Rezoning Application: PD 25-1387
Zoning Hearing Master Date: March 23, 2026
BOCC CPA Public Hearing Date: May 12, 2026

APPLICATION NUMBER: PD 25-1387

AGENCY REVIEW COMMENT SHEET

Project Name: 6214 E. Sligh Multi-Family Community Planned Development

8.0 PROPOSED SITE PLAN (FULL)

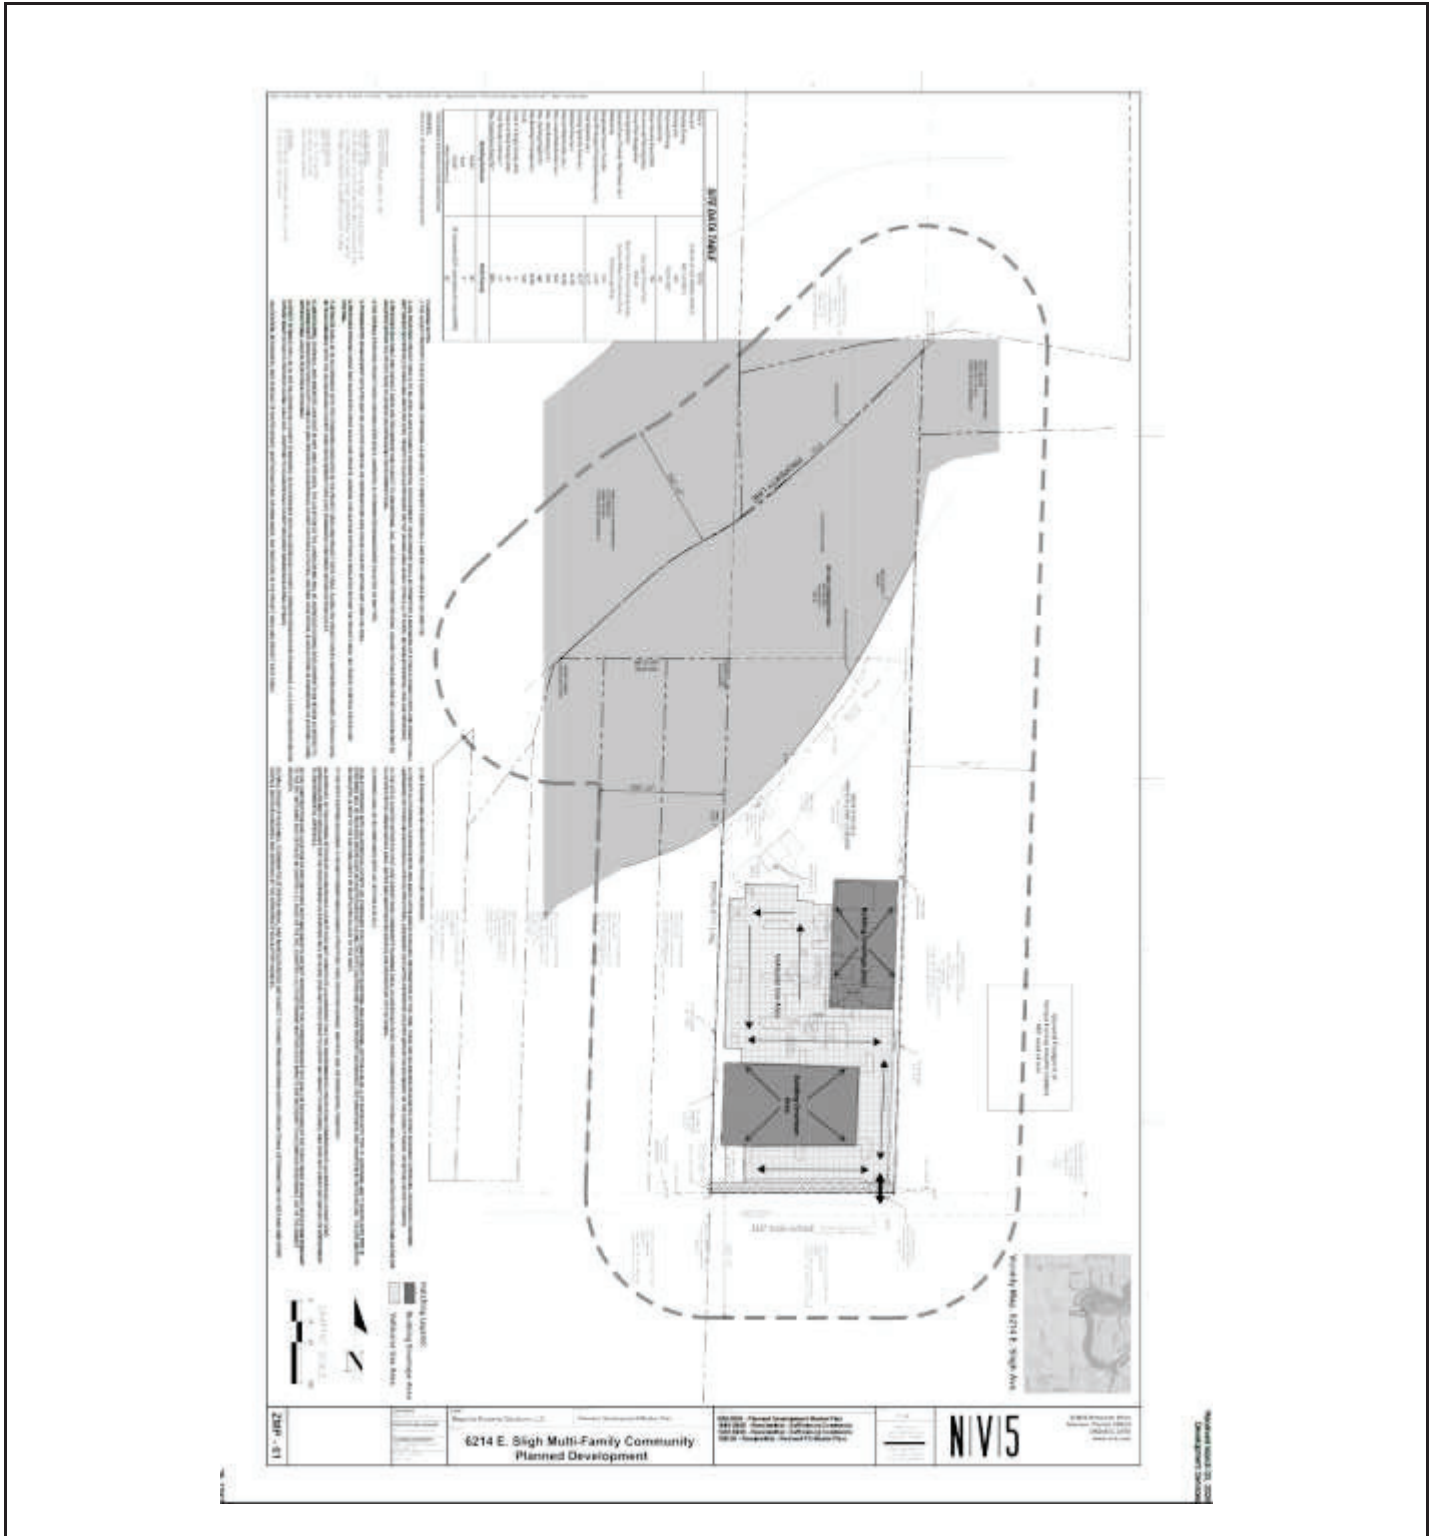
- Prior to site plan certification, the PD Site Plan shall be revised to change the right of way preservation label to state; “+/- 12.5 Feet of Right-of-Way Preservation per Hillsborough County Corridor Preservation Plan.”

- Prior to site plan certification, the PD Site Plan shall be revised to change the right of way preservation label to state; “+/- 12.5 Feet of Right-of-Way Preservation per Hillsborough County Corridor Preservation Plan.”

1 CONCEPTUAL SITE PLAN SKETCH
 1" = 50'-0"

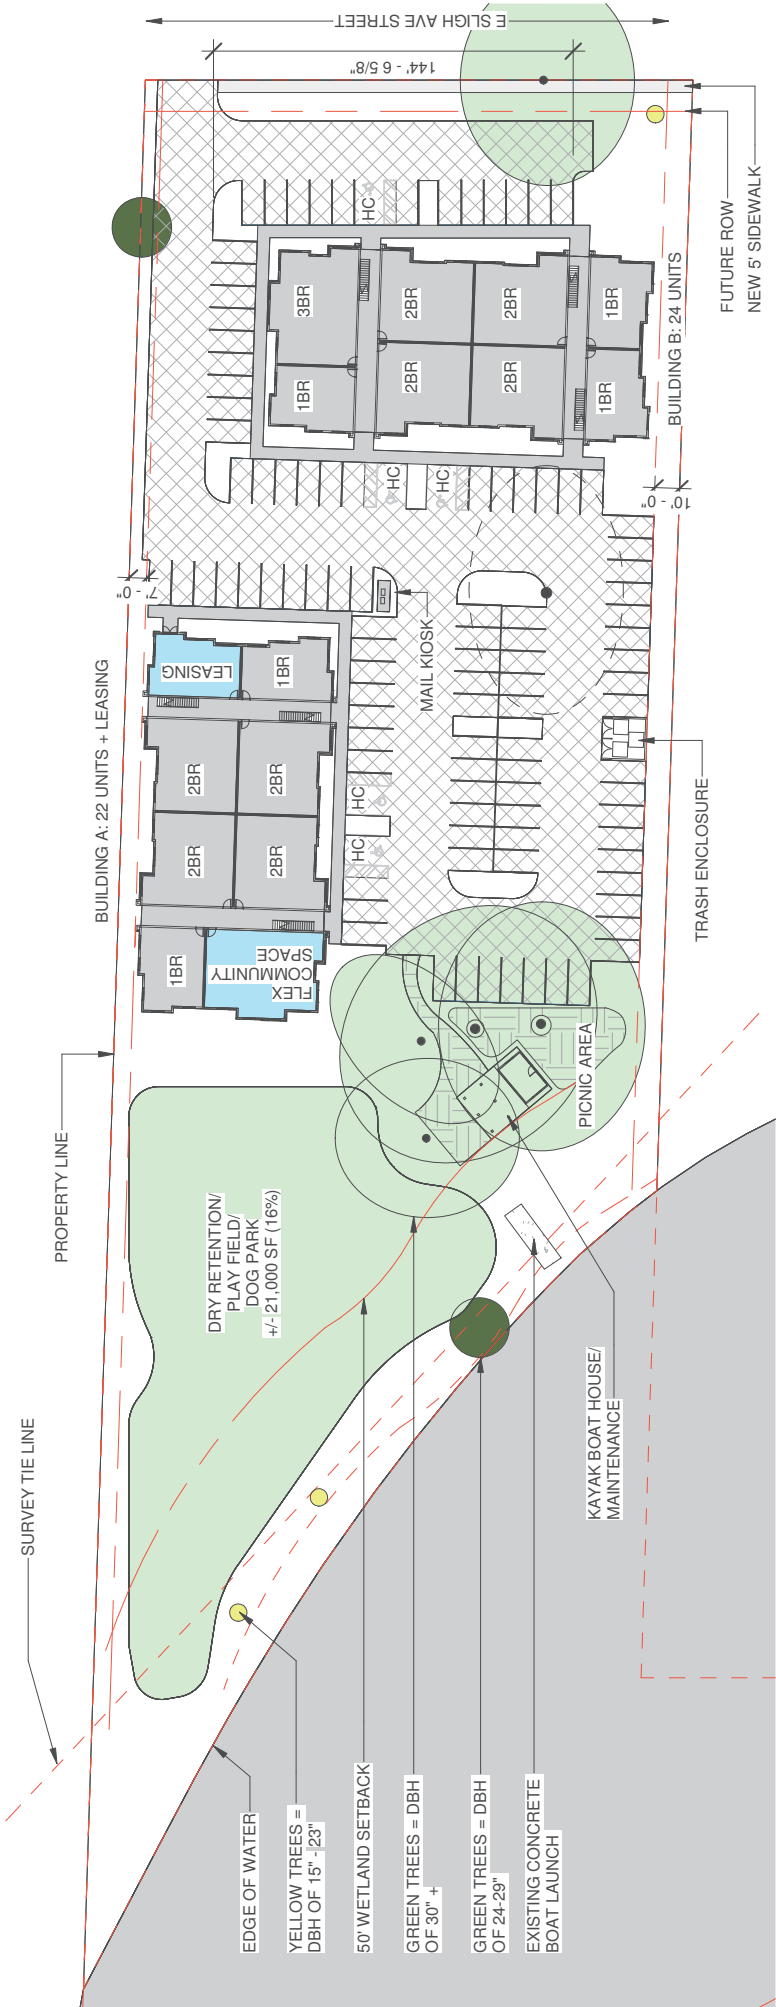
The subject property is in for rezoning to Planned Development to allow for the development of 47 townhomes, as is shown on the attached **Site Plan** and **Location Map**. This variance is to request that the developer not be required to meet LDC driveway spacing.

- c. Without the variance, reasonable access cannot be provided. *This is a relatively low speed collector with a 35 mph posted speed. The low speed reduces the potential for conflicts. In addition, this segment of Sligh Avenue includes other nearby driveways for multi-family land uses; thus, the curb cut in this location meets driver expectation, and constitutes reasonable access to this parcel.*

1 CONCEPTUAL SITE PLAN SKETCH
 1" = 50'-0"

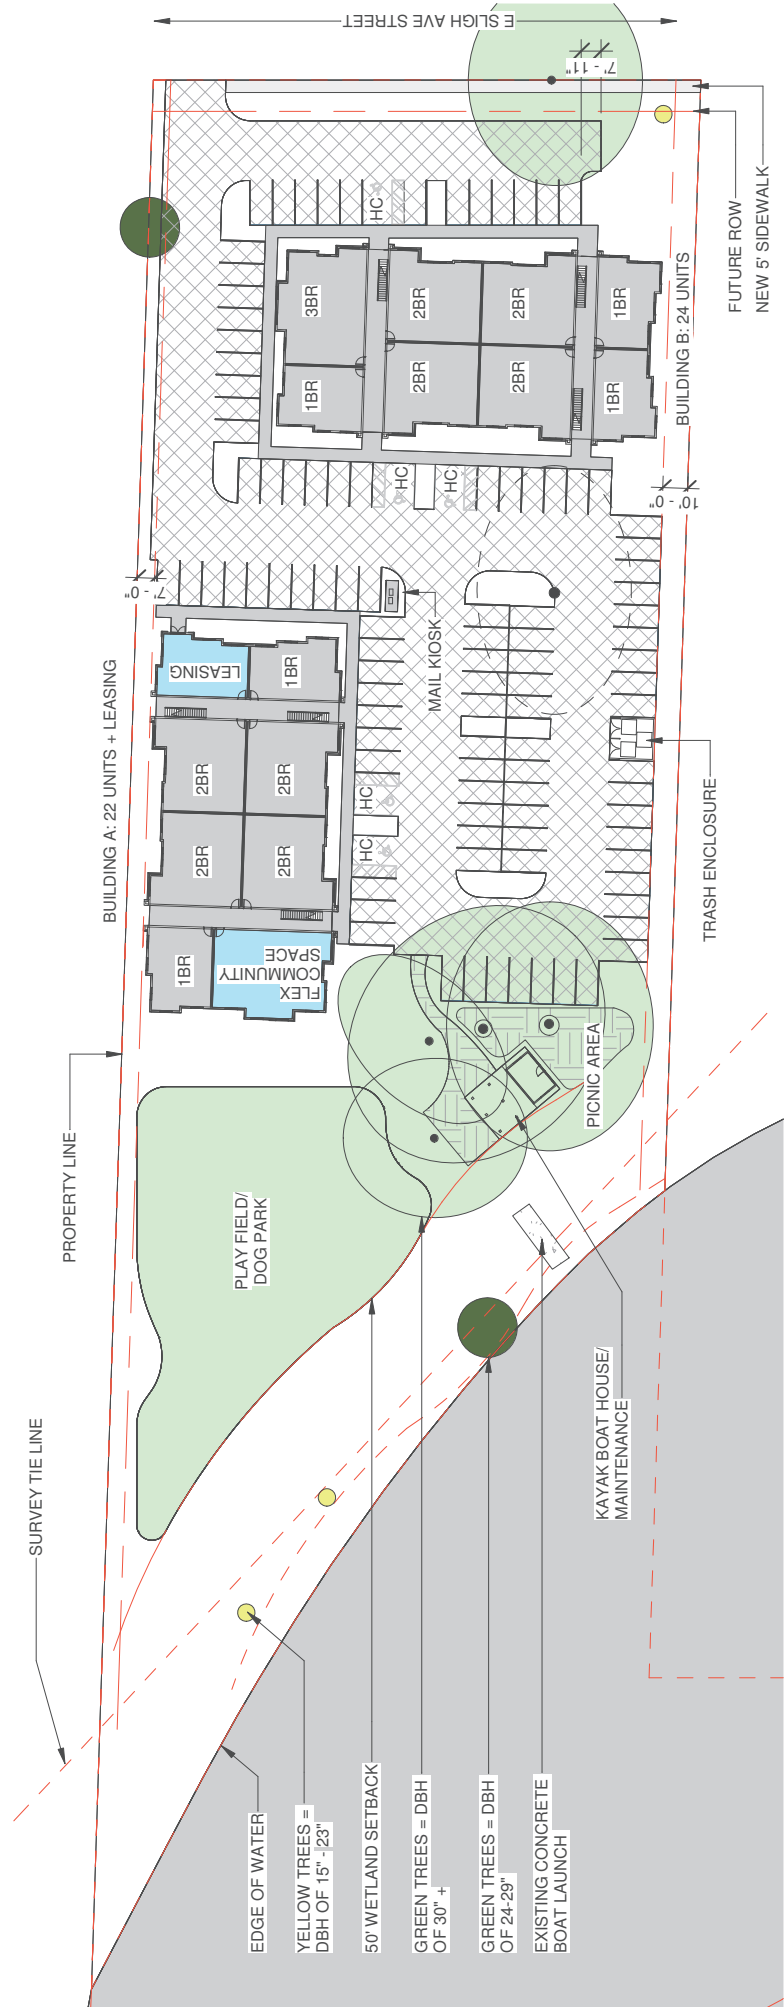
The subject property is under review for a proposed rezoning, as is shown on the attached **Site Plan**, to include a multifamily community with up to 47 units. This design exception, per the Transportation Technical Manual (TTM), is to meet Hillsborough County Land Development (LDC) Section 6.04.03.L – Existing Facilities. East Sligh Avenue adjacent to the site will not be constructed *fully* to TTM standards, but instead the request is to allow for some reasonable improvements as described herein.

driveway (Halifax River Drive/East Sligh Avenue) and are attached. As the attached tables derived from the counts indicate, 77.8% of ingressing project traffic will be eastbound, constituting lefts into the site. When that percentage is multiplied by the inbound trips (See Trip Generation Table based upon the Eleventh Edition of the ITE Trip Generation Manual.) for low-rise multifamily housing (26*0.778= 20 vh), the resultant 20 left turns do not EXCEED the 20 vph threshold warranting a left turn.

The developer proposes to build a sidewalk along the north side of East Sligh Avenue from Halifax River Drive to the pedestrian gate for the Parc Place Villas where it would connect to existing sidewalk (See Exhibit.). This would be 1,016 feet of new sidewalk in addition to that which the developer is already required to construct along his frontage.

3. *JUSTIFICATION FOR THE REQUEST* - Providing the sidewalk will improve pedestrian safety and accessibility along East Sligh Avenue. It should be noted that sidewalk is being constructed some distance from the site because it cannot be constructed closer to the site. As described above, there is no sidewalk in front of the River Trace and River Tree Landings apartments. But, there are large trees and other obstructions and inadequate available right-of-way. So, the new sidewalk is proposed from Halifax River Drive to the pedestrian gate for the Parc Place Villas. This would be 1,016 feet of new sidewalk directly across from King High School and the adjacent county community center and park. (Note that there is a pedestrian crosswalk across Sligh Avenue at 56th Street.) The above-described exhibit that shows the 1,016 feet of proposed new sidewalk, shows that the grass is worn away in this area due to existing pedestrian activity, and there is pedestrian demand for this sidewalk. This right-of-way constraint is also the reason that the required 10 foot shoulders cannot be constructed. The required right-of-way width for C1&C2-2U is 154 feet, and only 50 feet of right-of-way are available on East Sligh Avenue.

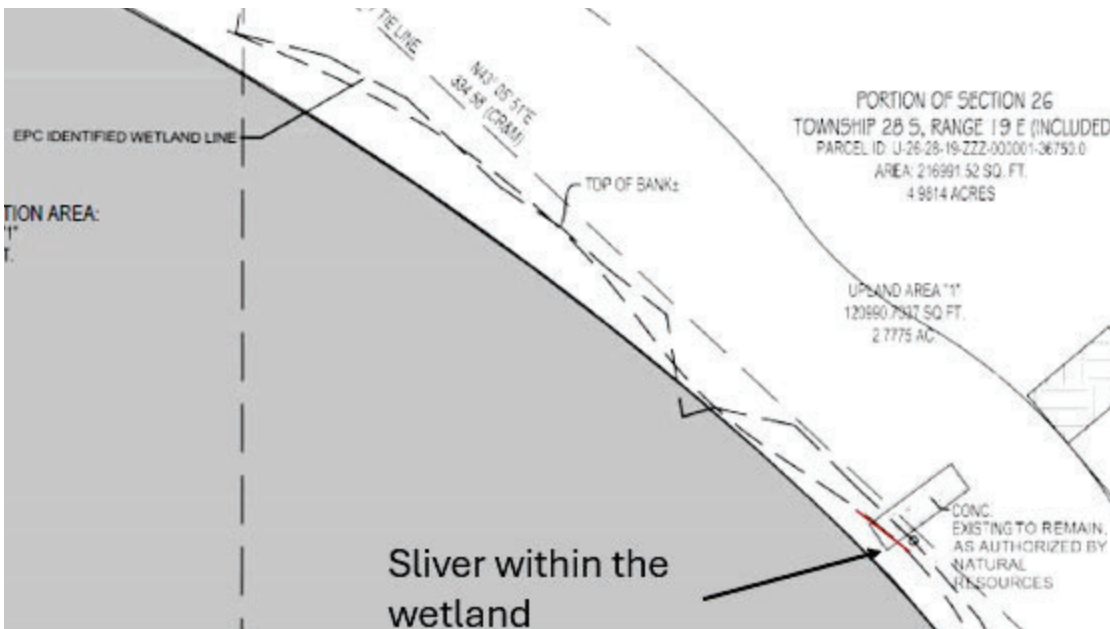
The most recent site plan appears to show a small portion of the concrete pad within the wetland area. Please note the following condition from EPC staff:

Natural Resources can only approve, as discussed, portions of the pad within the 30' wetland setback area and not the wetland itself.

The construction and location of any proposed wetland impacts are not approved by this correspondence but shall be reviewed by EPC staff under separate application pursuant to the EPC Wetlands rule detailed in Chapter 1-11, Rules of the EPC, (Chapter 1-11) to determine whether such impacts are necessary to accomplish reasonable use of the subject property.
